Figure 2.4.3-1. Hourly Distribution of the Probable Maximum Precipitation for the Swan Creek Watershed

Figure 2.5.1-1 Fermi 3 Site Regional Physiographic Map
(Reproduced from Fermi 3 COL FSAR Figure 2.5.1-202)

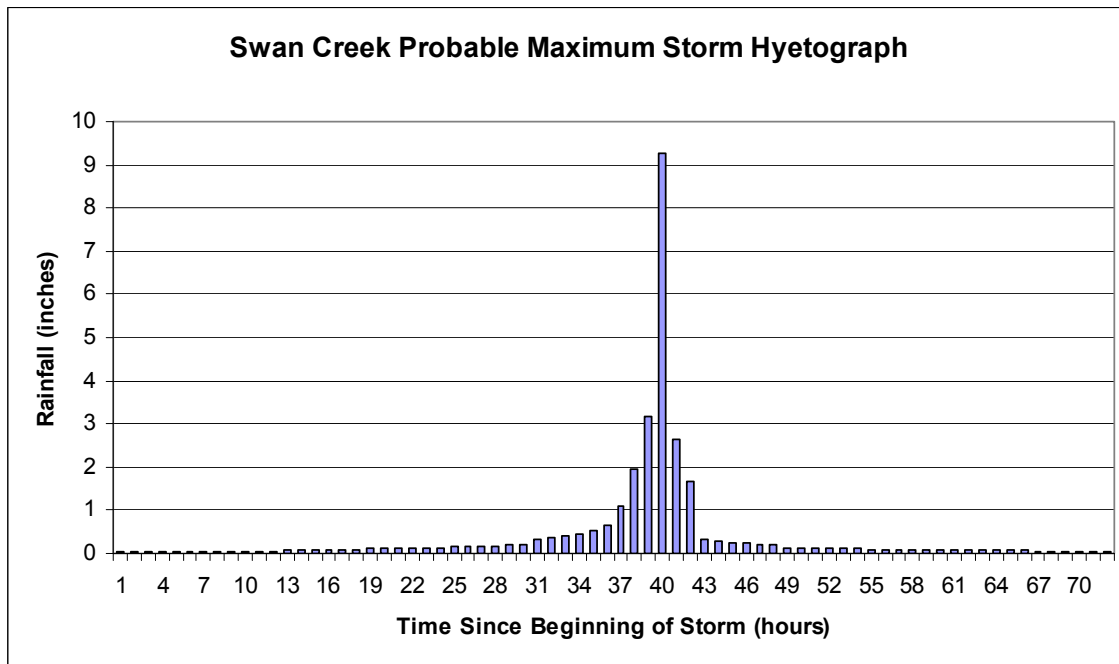
The applicant's input and output values for the HMR-52 program were very similar to the staff's. Both the staff and the applicant used a value of 0.302 for the ratio of the 1 to 6 hour storm. The staff found a maximum storm orientation of 309 degrees and the applicant found a maximum storm orientation of 311 degrees. The depth-area-duration curves used by the applicant were slightly larger overall than those used by the staff, and thus the applicant's analysis was more conservative. Therefore, the applicant's input values were found to be acceptable. The applicant calculated a PMP of 28.9 from the HMR-52 software, the same value determined by the staff's calculation.

Figure 2.4.3-2. Hourly Distribution of the Probable Maximum Storm with Snowmelt for the Swan Creek Watershed

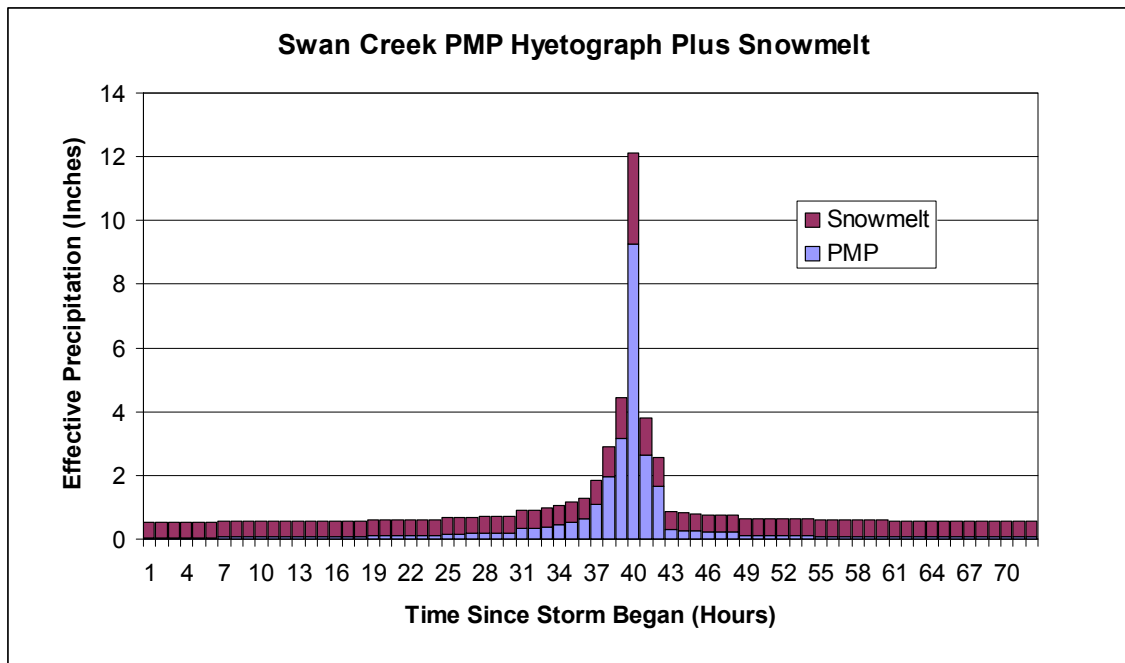
The staff-calculated PMP with snowmelt for the Swan Creek Watershed shown in Figure 2.4.3-1 above can be directly compared to Figure 2.4-XX-3 submitted by the applicant with the response to RAI 2.4.2-1, dated September 30, 2009 (ADAMS Accession No. ML092790561). The staff finds the applicant’s calculation of PMP with snowmelt to be acceptable, because the applicant’s PMP is the same as the value calculated by the staff.

Figure 2.4.3-3. Probable Maximum Flood Runoff using HEC-HMS 3.1.0 Rainfall-runoff Model

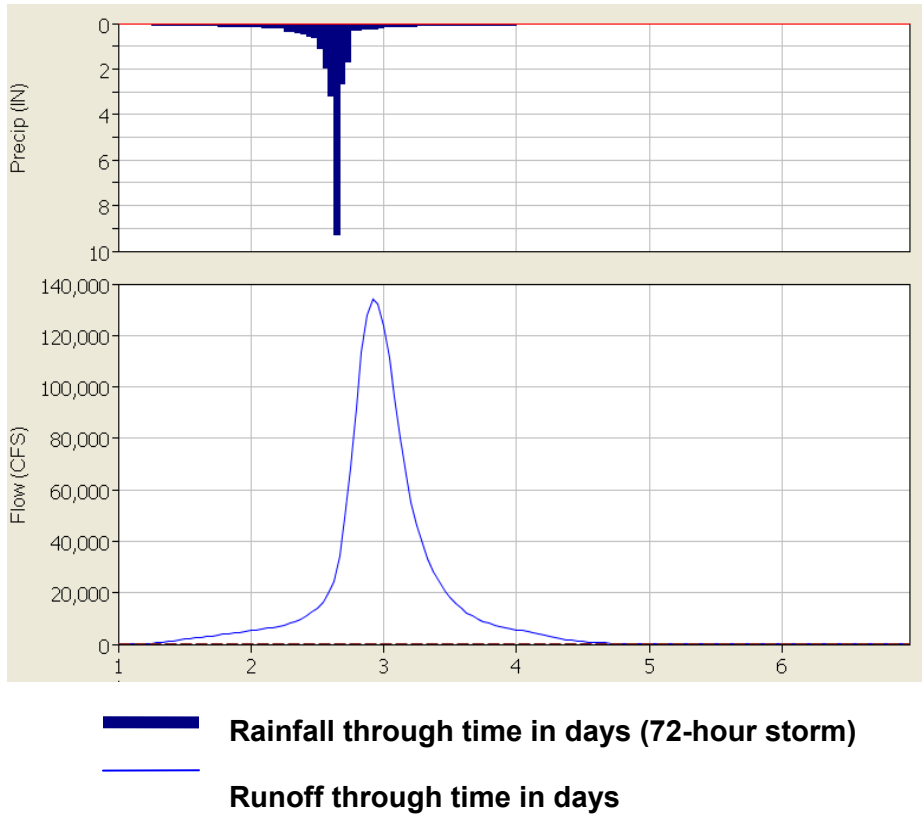
In Figure 2.4.3-3, the staff developed flood hydrographs based on the parameters discussed above. By developing an independent hydrograph, Figure 2.4.3-3 can be directly compared with Figure 2.4-219 of the FSAR to examine the PMF runoff calculated by the staff versus the PMF runoff calculated by the applicant.

Figure 2.4.3-4. Probable Maximum Flood with Snowmelt Runoff using HEC-HMS 3.1.0 Rainfall-Runoff Model

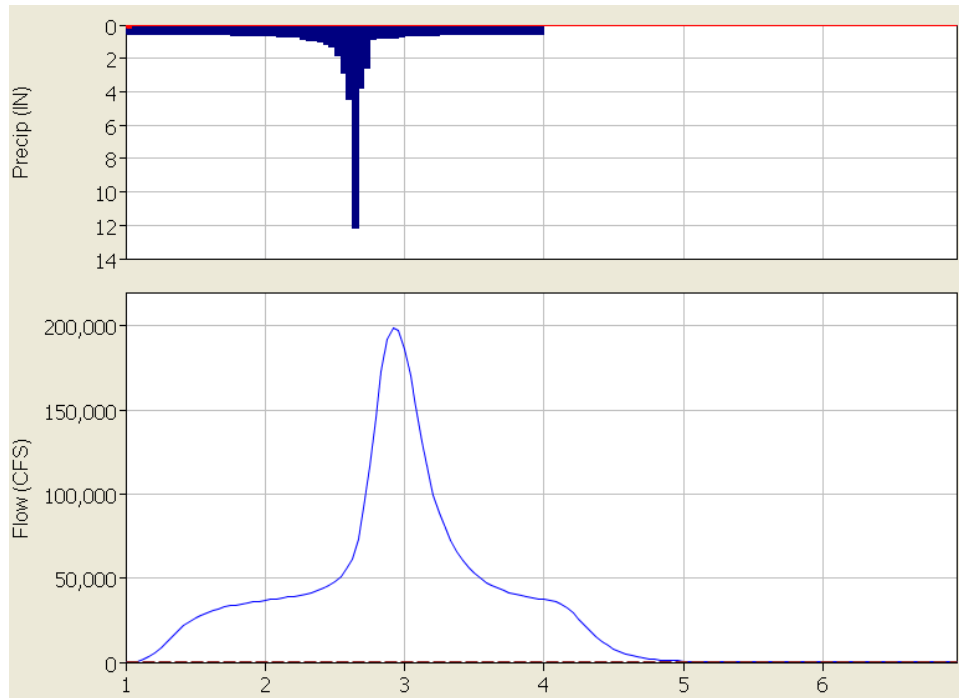
The NRC staff independently calculated the PMF with snowmelt for Swan Creek and obtained a value of 199,000 cfs, which is approximately 18 percent higher than the value presented in the response to RAI 2.4.2-1, dated September 30, 2009 (ADAMS Accession No. ML092790561).

In Figure 2.4.3-4, the staff independently developed a flood hydrograph that include snowmelt. The staff hydrograph in Figure 2.4.3-4 can be directly compared with Figure 2.4-2-XX-4 of the response to RAI 2.4.2-1, dated September 30, 2009 (ADAMS Accession No. ML092790561) to examine the runoff from the PMF plus snowmelt calculated by the staff versus the PMF plus snowmelt runoff calculated by the applicant.

Figure 2.4.5-1. Wave Height and Bathymetry of the Western Lake Erie Derived by STWAVE

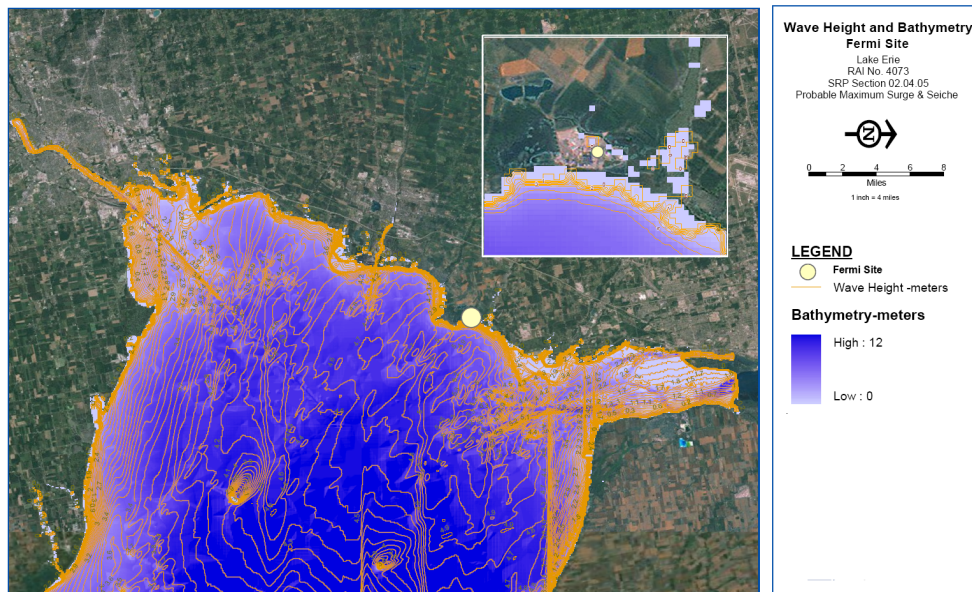
In the responses to RAI 2.4.5-3 and RAI 2.4.5-7, the staff verified the results derived by the applicant by modeling the entire area of Lake Erie using the model grid of 100 m using STWAVE. The resulting distribution of wave heights is shown in Figure 2.4.5-1.

Figure 2.4.5-2. STWAVE Data Points Near Fermi 3

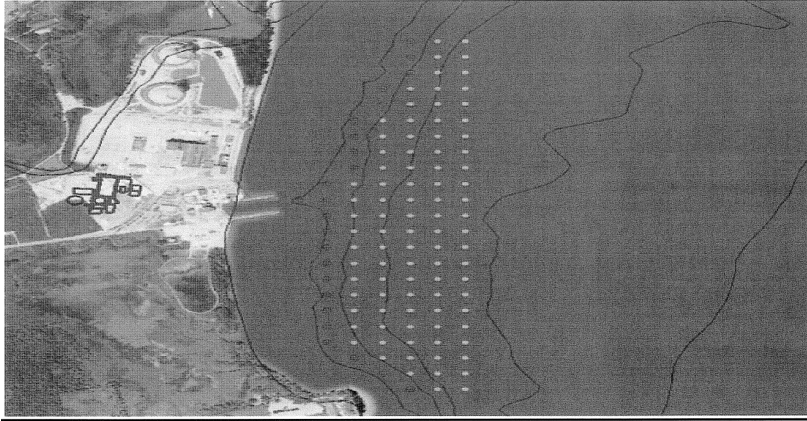
The STWAVE data points near the Fermi 3 are shown in Figure 2.4.5-2. The wave periods at all these points are 11.1 seconds. The wave height at the point near Fermi 3 is 3.7 m. The

wave parameters selected by the applicant using STWAVE are conservative based on the staff's independent verification using additional data received in RAI responses. These parameters, including wave period and distribution of wave height, were used for further calculation of wave action across the shore.

Figure 2.4.5-3. Cross Section from the STWAVE Point to the Fermi 3 Safety-Related Structure

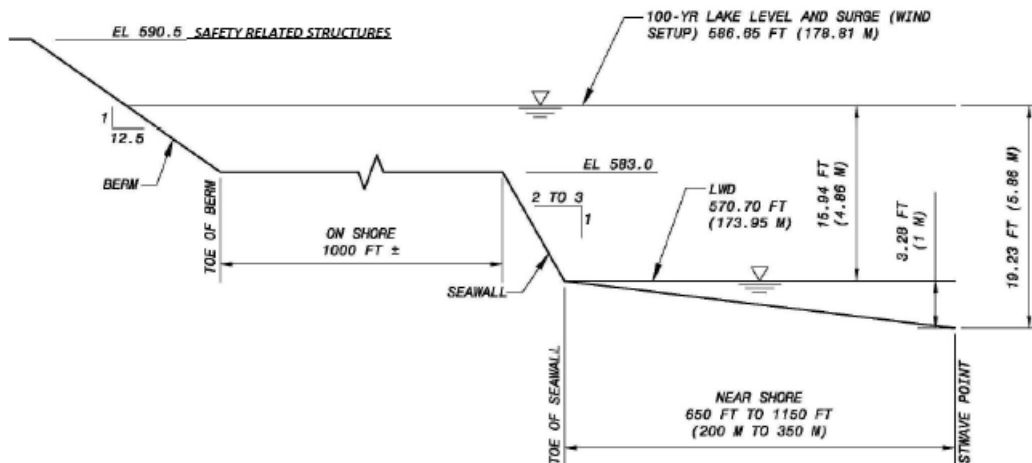
In response to RAI 2.4.5-8 the applicant provided the information regarding the cross section from the STWAVE point to the Fermi 3 safety structures and the calculated the wave characteristics across the shore (Figure 2.4.5-3). The staff verified that all information is correct by checking the cross section data to that information used in the model. The shore profile data were used in the model input for the calculation of the breaking wave and wave run-up.

Figure 2.5.1-5 Photographs of Strata in the Denniston Quarry, Monroe, Michigan.

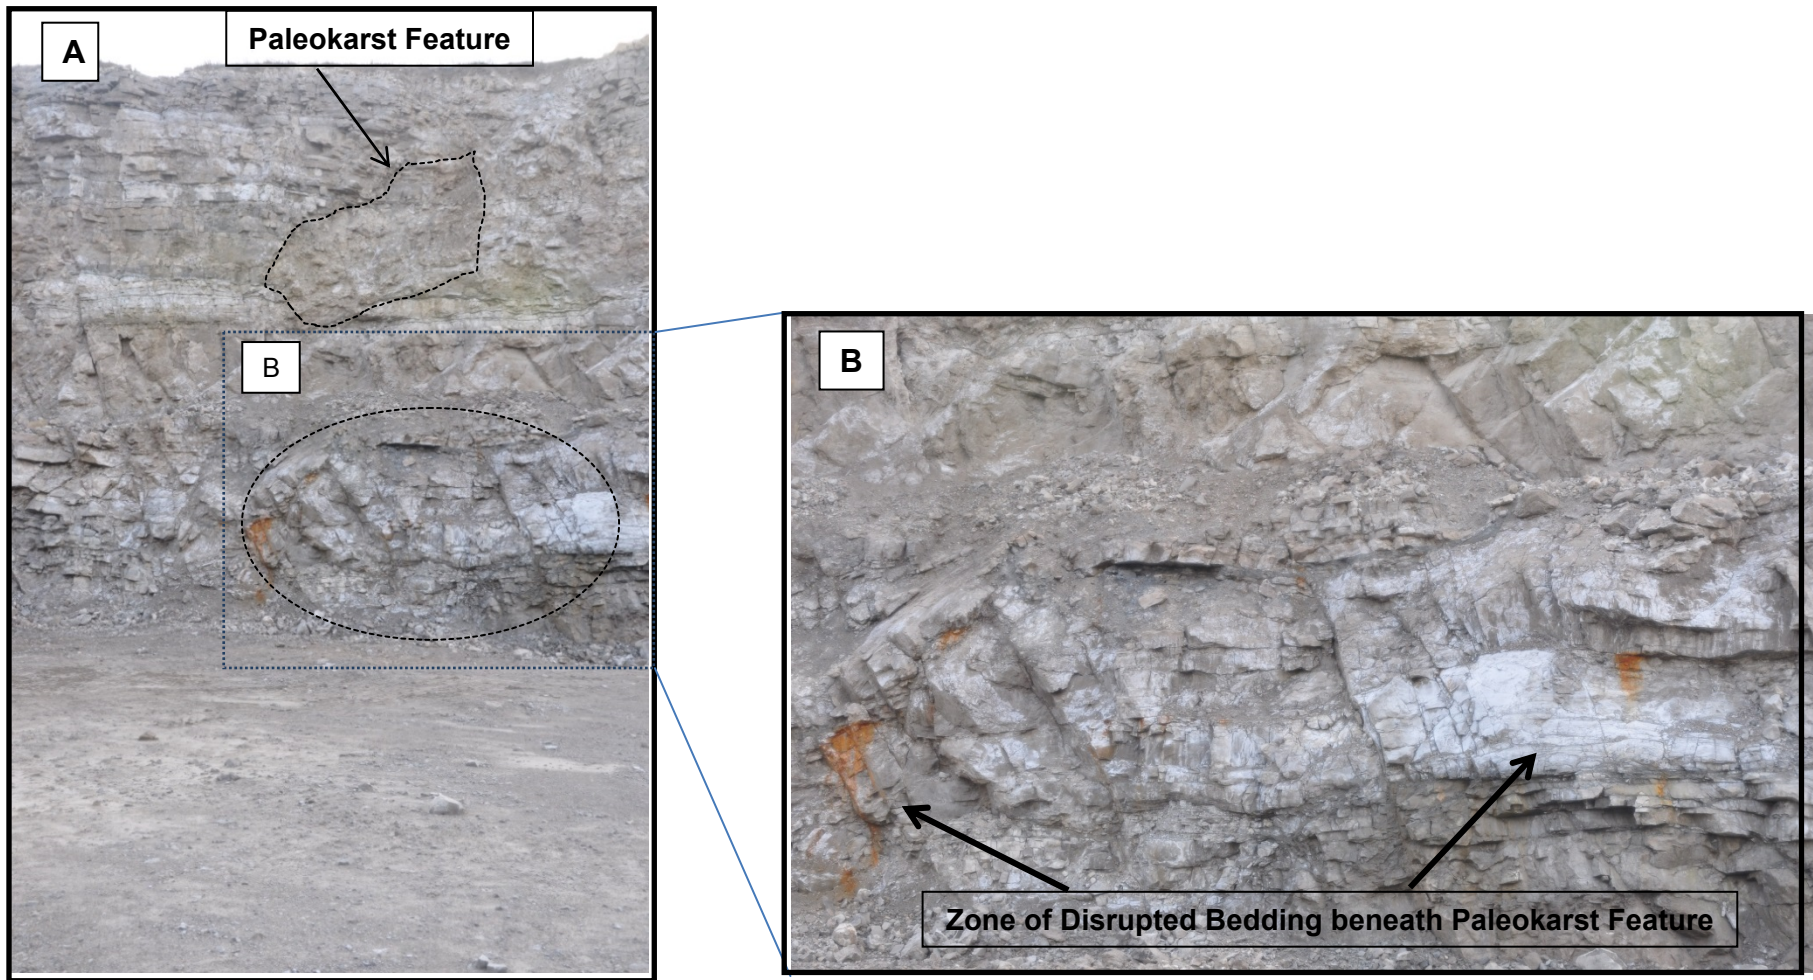
During the NRC staff's visit to the Denniston Quarry in Monroe County, Michigan, as part of a November 2009 Fermi 3 COL site audit, the staff noted at least three zones of disrupted bedding exposed in the quarry walls. These disrupted zones suggest possible faulting of the Bass Islands Group. In one location, disrupted bedding exists beneath an interpreted paleokarst feature (located near the top of the geologic section) and suggests that the paleokarst development may be associated with faulting at depth. Figure 2.5.1-5 in this SER shows this paleokarst feature above a zone of disrupted bedding in the Bass Islands Group. In a second quarry location, a zone of disrupted bedding exists with mostly undisturbed bedding on either side. This second zone appears to be at least seven to ten meters wide; contains disrupted bedding from the top to the bottom of the exposed wall; and is flanked by relatively undisturbed bedding on both sides. The third zone of possible disturbed bedding was visible in a distant wall and could be related to vertical offsets within the Bass Islands Group.

Figure 2.5.2 -8 Earthquakes with Magnitudes Equal to or Greater than 3.0 in the CEUS between 2009 and 2012

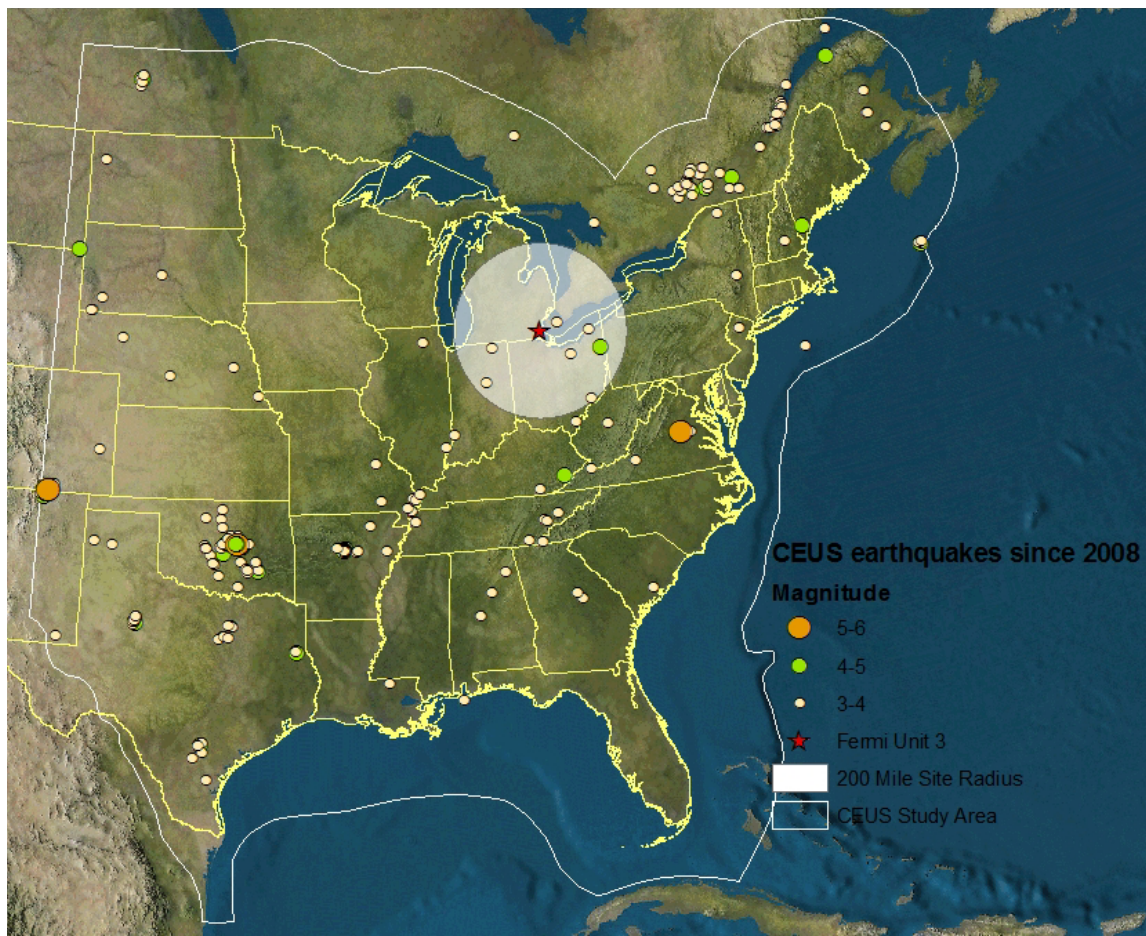
The staff developed a supplementary earthquake catalog covering the CEUS region from 2009 through 2012, in order to evaluate the completeness of the applicant's updated catalog and subsequent conclusions. The staff used the USGS ANSS, which is in Figure 2.5.2-8 in this SER. The staff compared this recent seismicity with the applicant's updated catalog in FSAR Figures 2.5.2-202 and 2.5.2-203. The staff concluded that the recent seismicity does not show any significant deviations from the applicant's updated seismicity catalog. Therefore, the staff concludes that the Fermi 3 earthquake catalog adequately characterizes the regional and local seismicity through 2012.

Figure 2.5.2-9 Plot Comparing the Staff's and the Applicant's 1-Hz Total Mean Hazard Curves for the Distributed Seismicity Source Zones

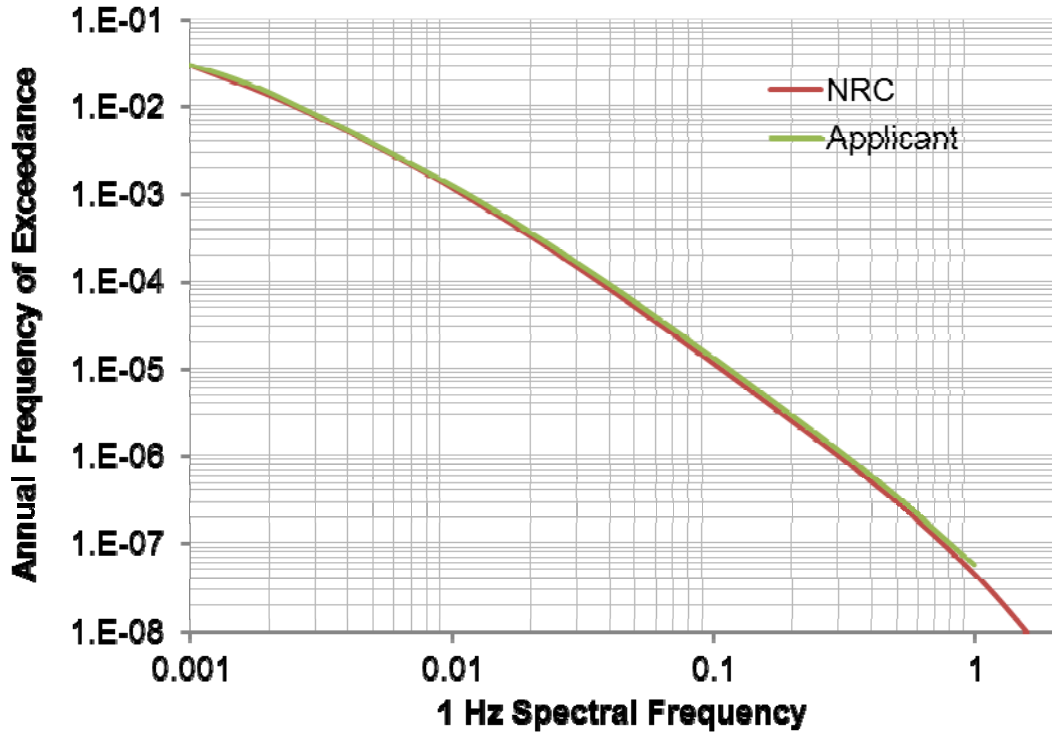
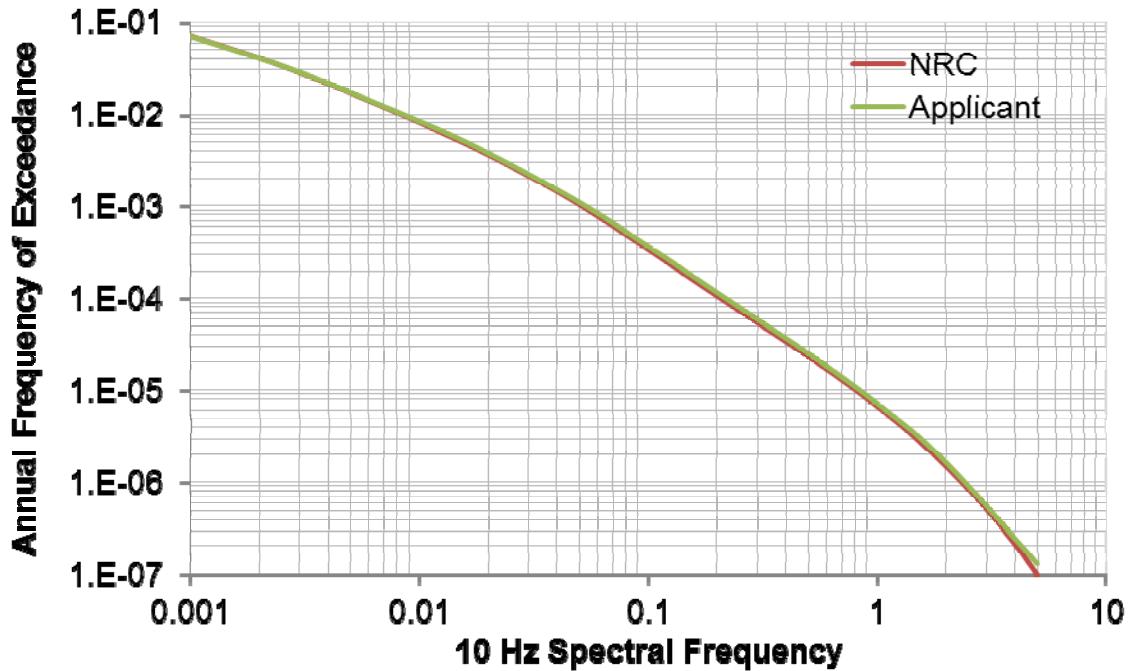
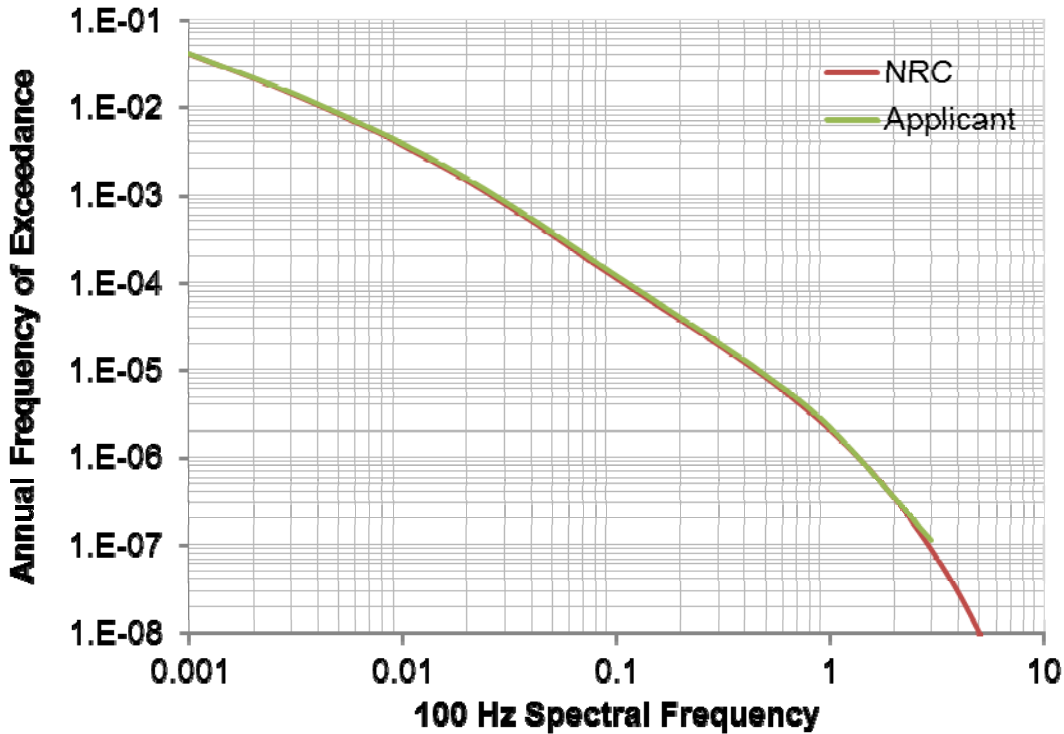
results are almost identical. This finding is illustrated in Figures 2.5.2-9 through Figure 2.5.2-11 in this SER showing the PSHA hard rock hazard curve results for 1, 10, and 100 Hz, respectively, for the distributed seismicity sources.
